**TOWN OF NEWBURGH  
PLANNING BOARD  
TECHNICAL REVIEW COMMENTS**

**PROJECT NAME:** ATHBOY ROAD 4-LOT SUBDIVISION  
**PROJECT NO.:** 24-36  
**PROJECT LOCATION:** SECTION 8, BLOCK 1, LOT 105  
**REVIEW DATE:** 29 MAY 2025  
**MEETING DATE:** 5 JUNE 2025  
**PROJECT REPRESENTATIVE:** CHRIS TERRIZZI, P.E. - CM TERRIZZI ENGINEERING, PLLC

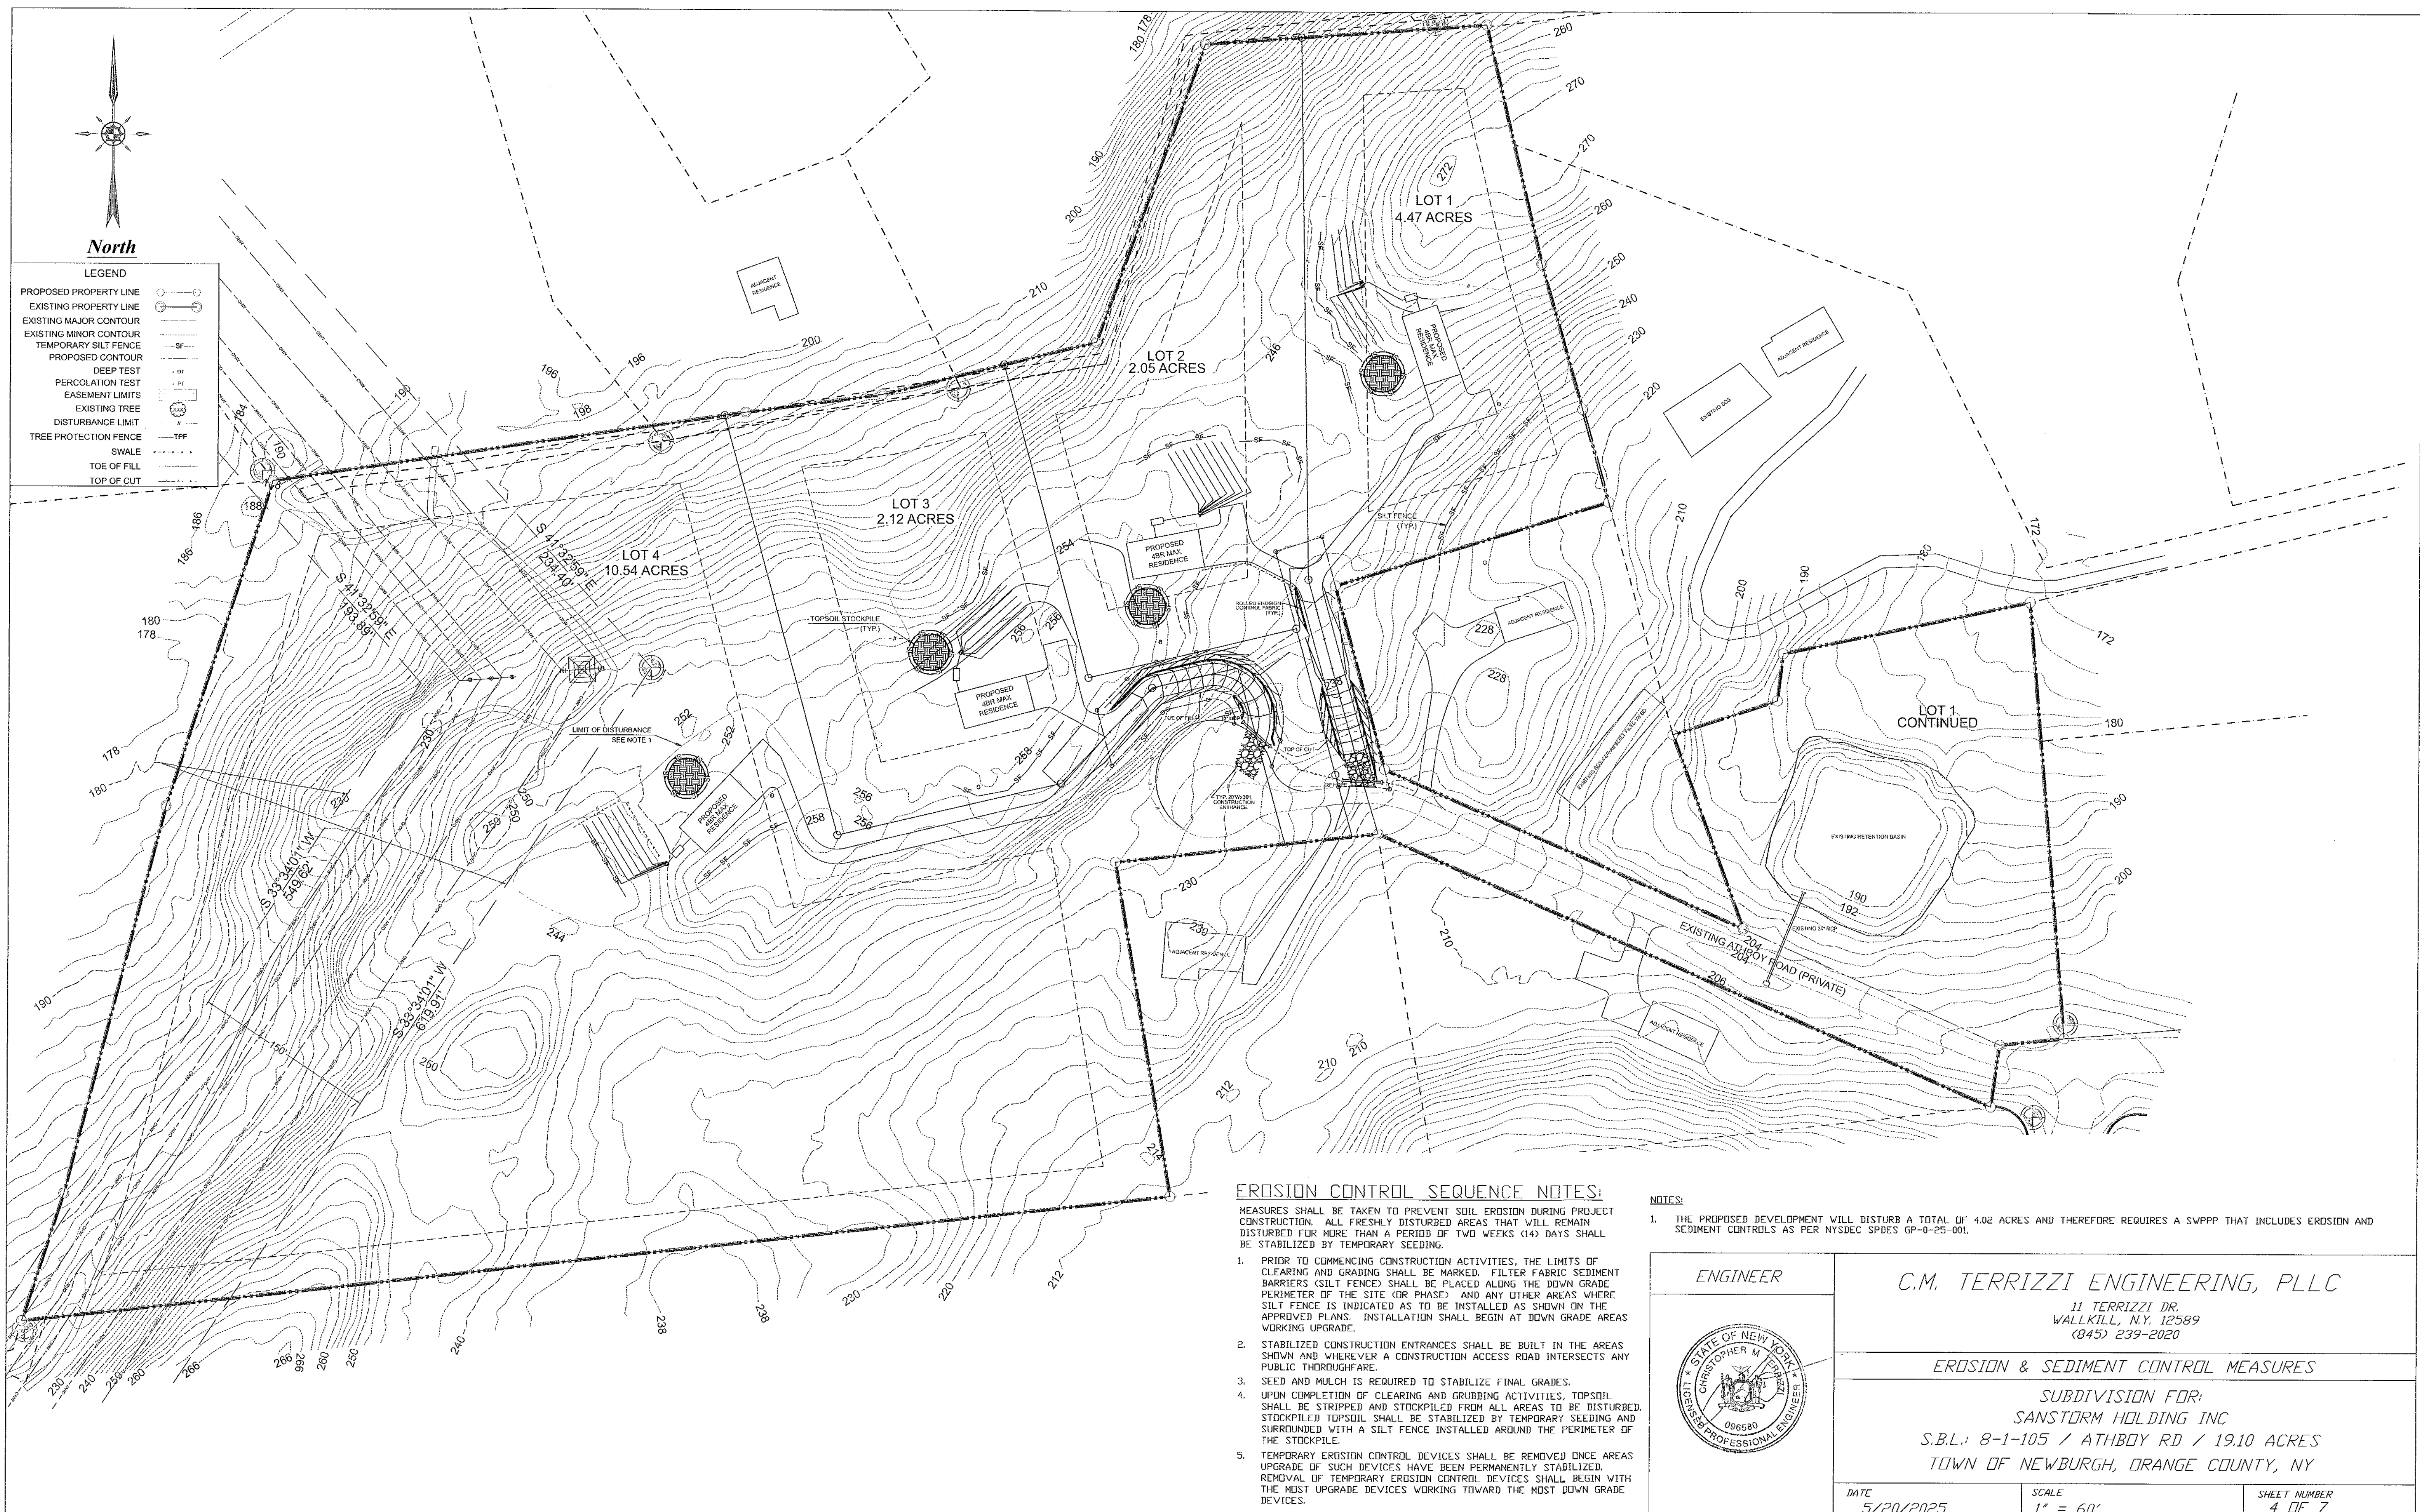
4. A SWPPP is under review by this office.
5. A Tree Preservation Survey has been performed. The Tree Preservation Survey was performed in the area including the limits of disturbance. Even within the limits of disturbance the project is under a threshold requiring any mitigation or restitution. Substantial number of trees exist outside the 4.5+/- acre area of disturbance on the 19-acre parcel.
